## TO ALL BIDDERS OF RECORD:

This Addendum forms a part of the Contract Documents and modifies the Drawings and Project Manual as hereinafter indicated.

Project  
**DEDHAM-WESTWOOD  
WATER DISTRICT**

Storage Facility and  
Site Improvements

NOTES:

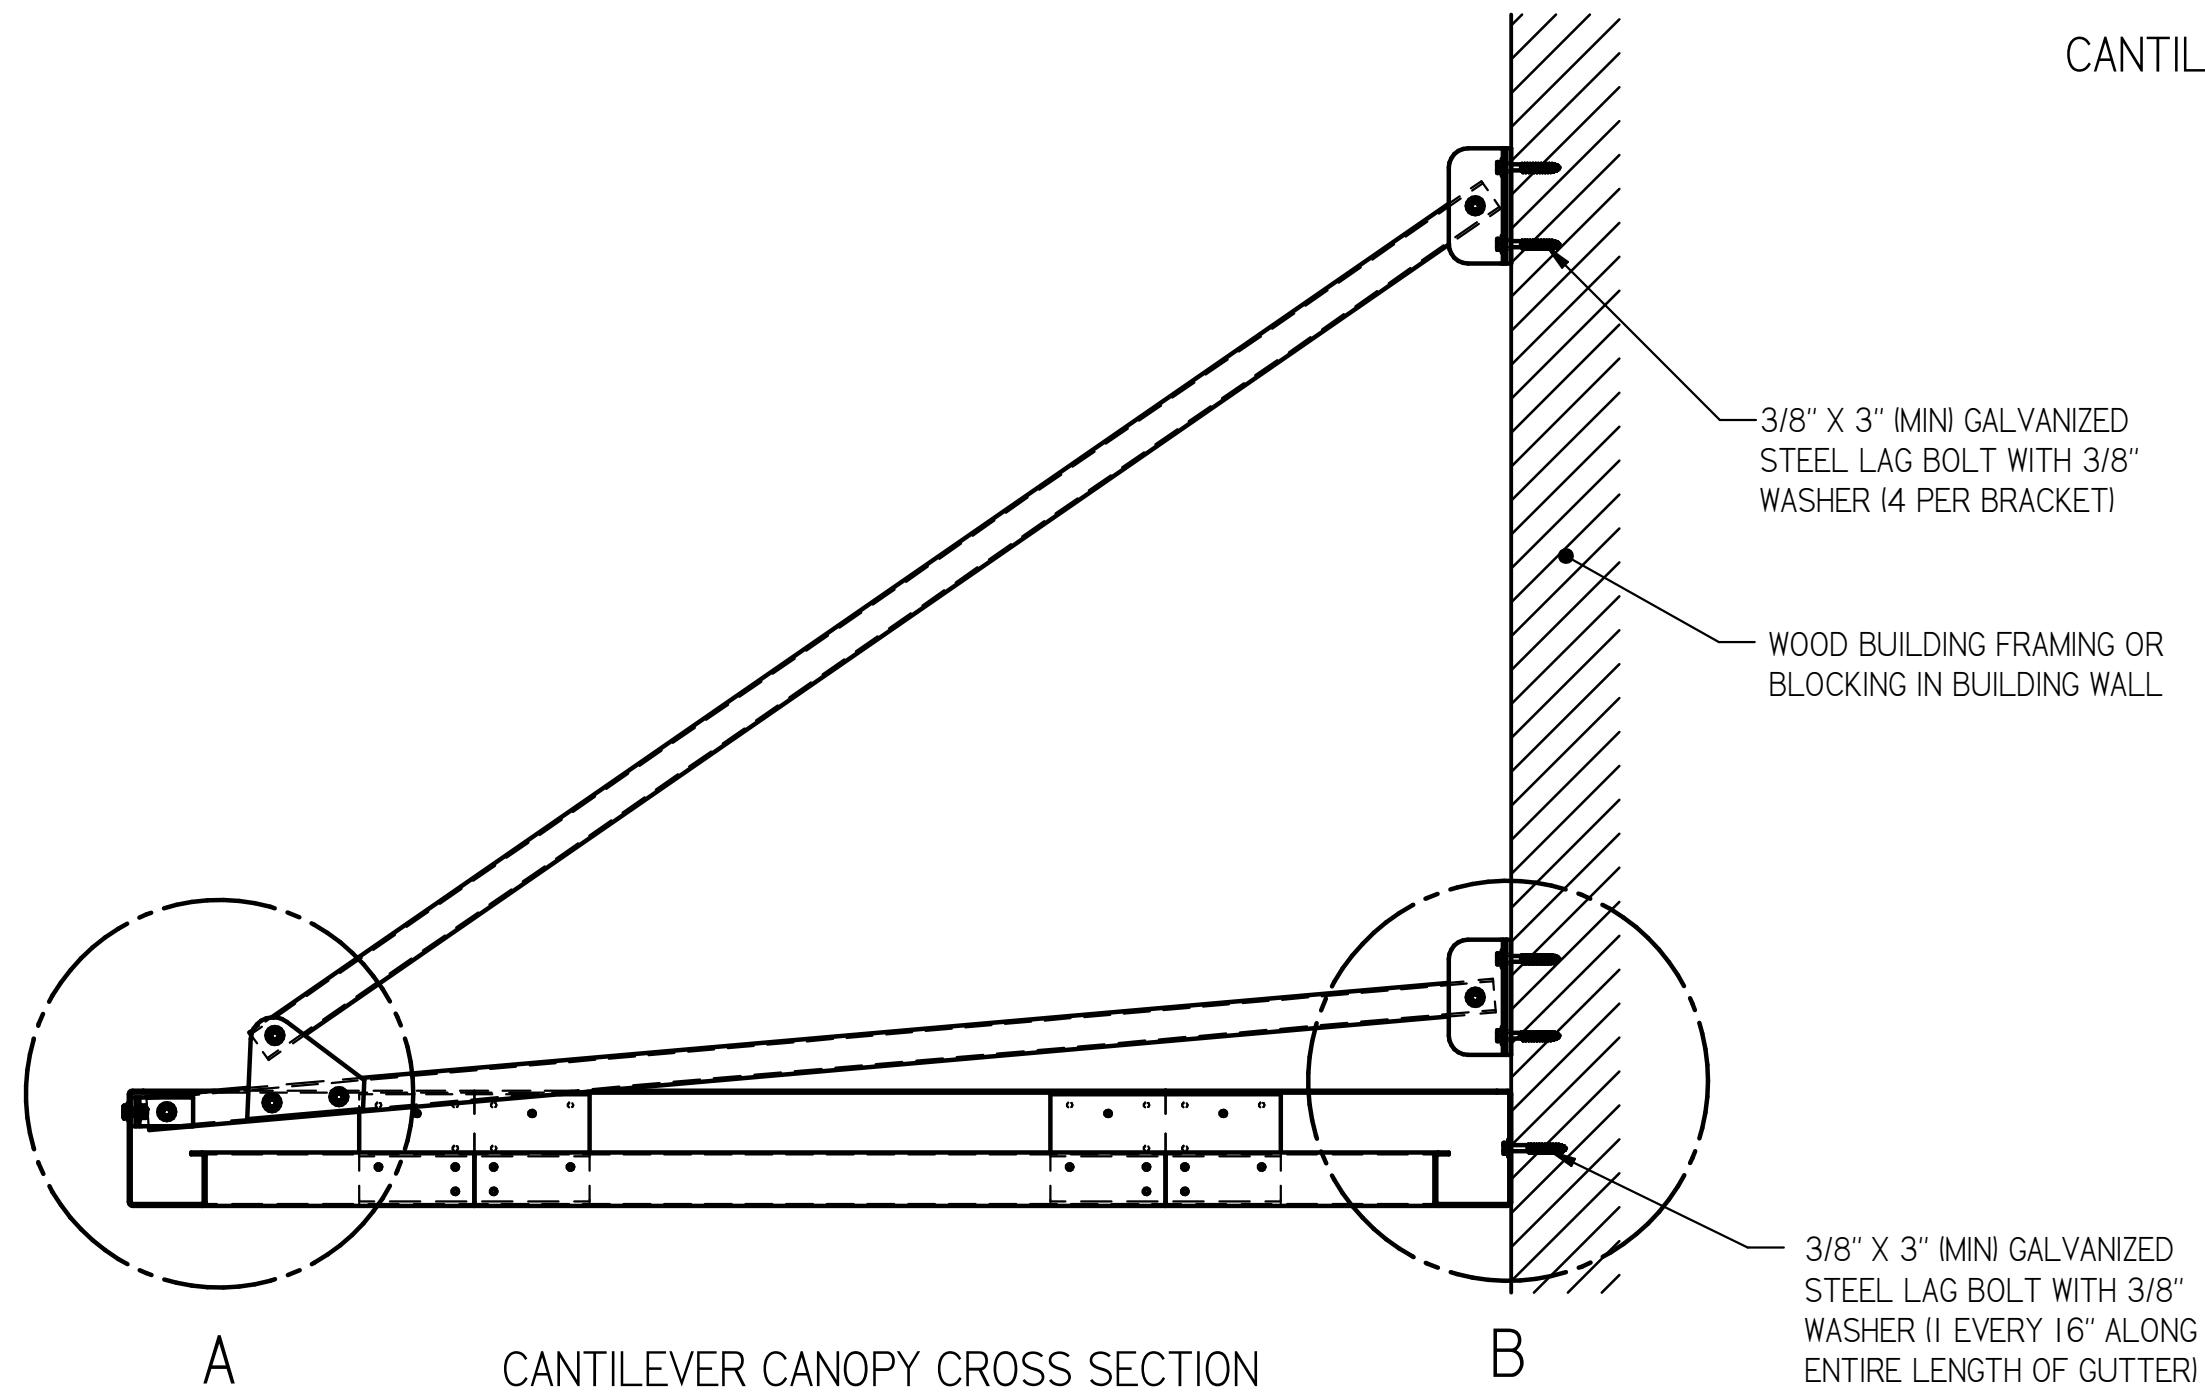
8. *Dedham-Westwood Water District prefabricated canopies. The spec section 05-9995 Prefabricated Canopy calls for two canopies that are supported by one pair of hanger rods. The*

*attached alternate product from Upside Innovation has two pairs of hanger rods. Will it be acceptable to carry this product in our base bid? Please confirm.*

**Response: This substitution for Upside prefabricated canopy is acceptable. Product documentation is included as part of this addendum for review.**
